PACIFIC GAS AND ELECTRIC COMPANY'S APPLICATION TO CONSTRUCT POTRERO TO HUNTERS POINT 115 kV CABLE PROJECT CPUC A.03-12-039

Mitigated Negative Declaration Response to Comments

November 19, 2004

Fig. 2 San Francisco / Peninsula Corridor Transmission System

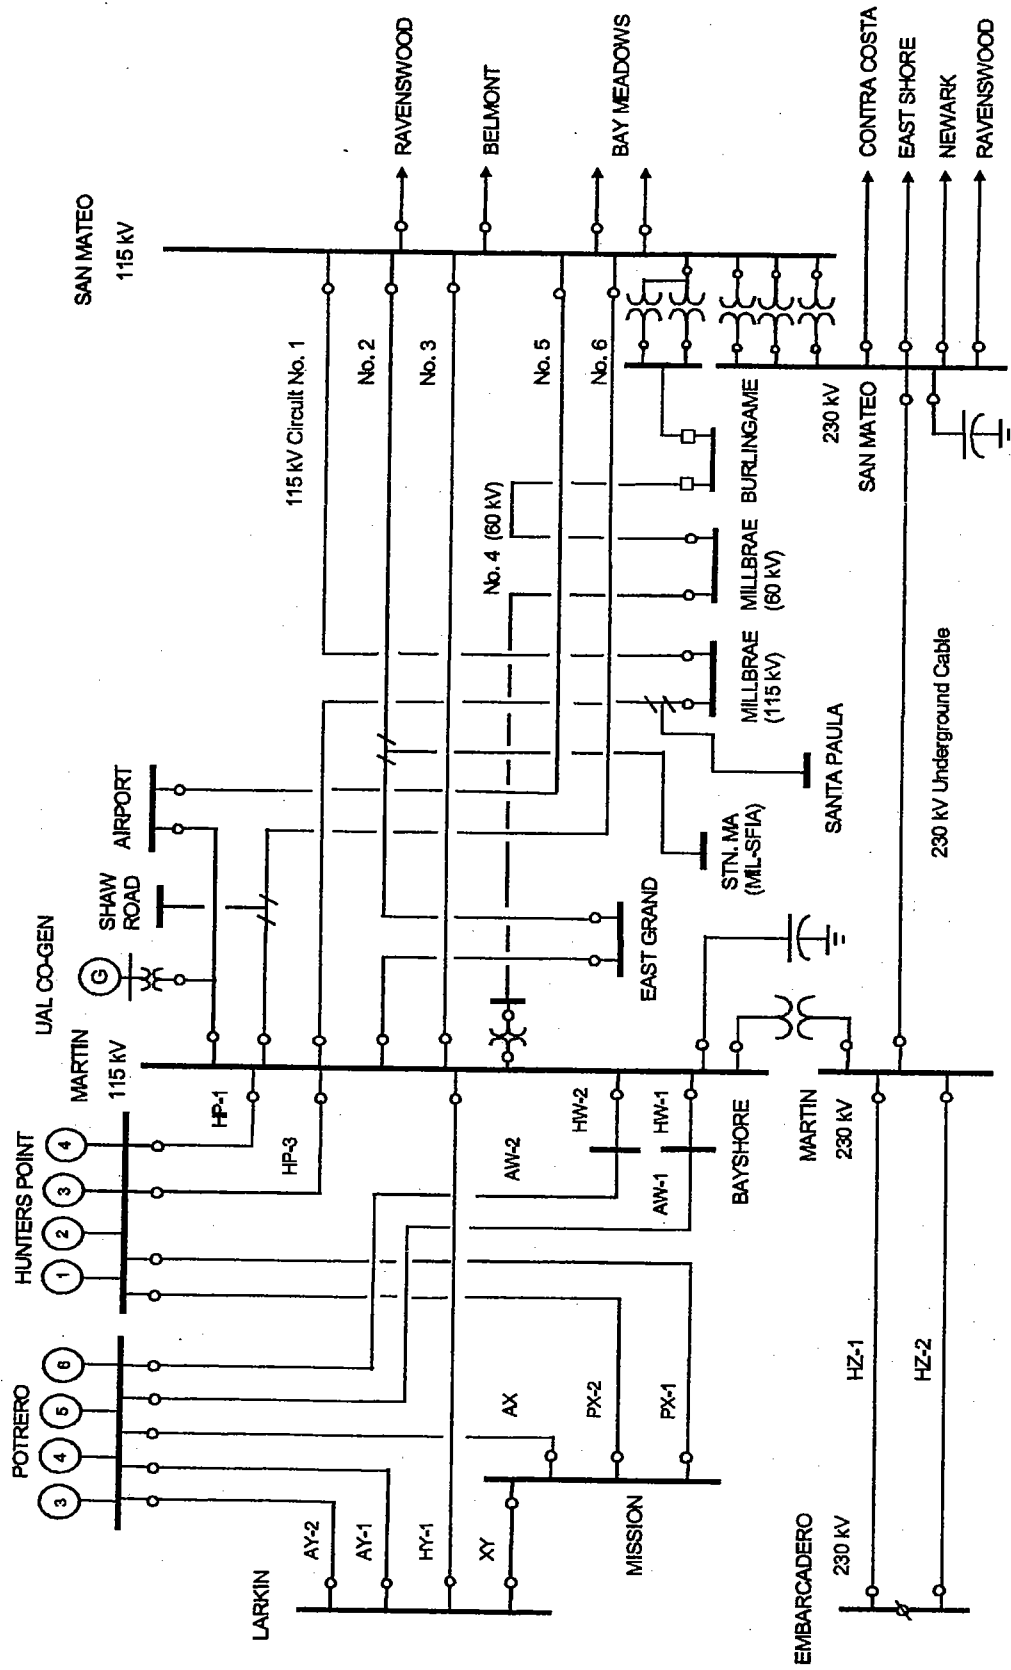
D1-1 The comment is regarding the purpose and need of the project. The commenter is concerned that the draft MND does not take into account that PG&E has two 115kV cable projects, a new cable from Potrero Substation and a new cable from the Martin Substation, proposed for connection to the Hunters Point Substation. The comment states that the installation of different cables may be a better solution for this overload problem and notes that the Hunters Point Substation will most likely have a low power distribution if needed at all for power distribution.

Using the CAISO California Grid Planning Criteria, PG&E transmission planners have evaluated various transmission alternatives capable of accomplishing the project objectives. According to this planning effort, constructing a new 115 kV underground cable from Potrero to Hunters Point is the most feasible and cost-effective means of better serving load and improving the reliability of PG&E's electrical system. The San Francisco Stakeholders Study Group, a broad-based, multidisciplinary study group led by the CAISO, has also studied these issues and has independently confirmed the need for the Potrero to Hunters Point 115 kV Cable Project. In December 2000, the CAISO formally approved this project.

The two electric transmission projects considered by PG&E for connection to the Hunters Point Switchyard are the Potrero to Hunters Point 115 kV Cable Project for which PG&E is seeking authorization to construct from the CPUC in application (A.03-12-039) and another project known as the Martin to Hunters Point 115 kV Single Circuit 115 kV Project which is in the planning stages. The Potrero to Hunters Point Project is needed to address more immediate load-serving capability needs in San Francisco and is an element that is needed to allow the closure of the Hunters Point Power Plant. The Martin to Hunters Point Project is needed to address future load-serving capability needs in San Francisco, assuming that the Potrero to Hunters Point Project is already operational. The addition of the Martin to Hunters Point cable increases load-serving capability in San Francisco more than the addition of the two cables (Potrero-Mission and Martin-Mission) mentioned in Mr. Carney's letter. Again, these power flow studies have been reviewed by the San Francisco Stakeholders Study Group, which concurred with the conclusion of the studies.

Building new lines from Potrero Substation to Mission Substation and Martin Substation to Mission Substation and shutting down two existing lines between the Hunters Point Switchyard and Mission Substation as suggested, would not serve as an alternative to PG&E's proposed Potrero to Hunters Point Project. Such a plan would remove needed circuits from the system serving San Francisco since the Hunters Point Switchyard is a vital part of the system.
